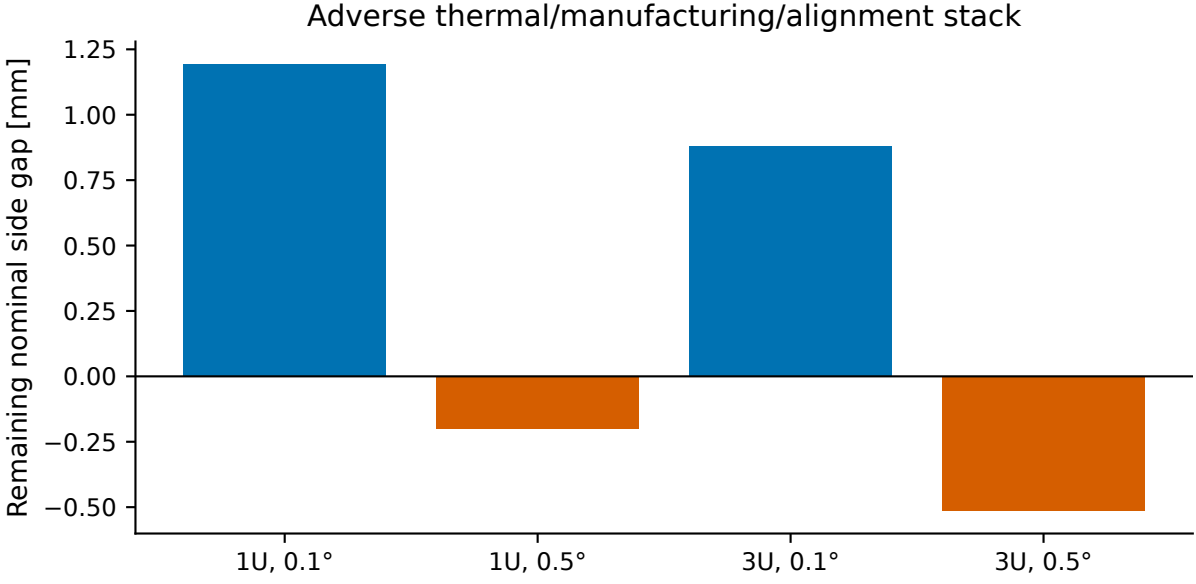
80°C versus 20°C datum; differential expansion assumed. 0.5° case fails; no manufactured fit verified.
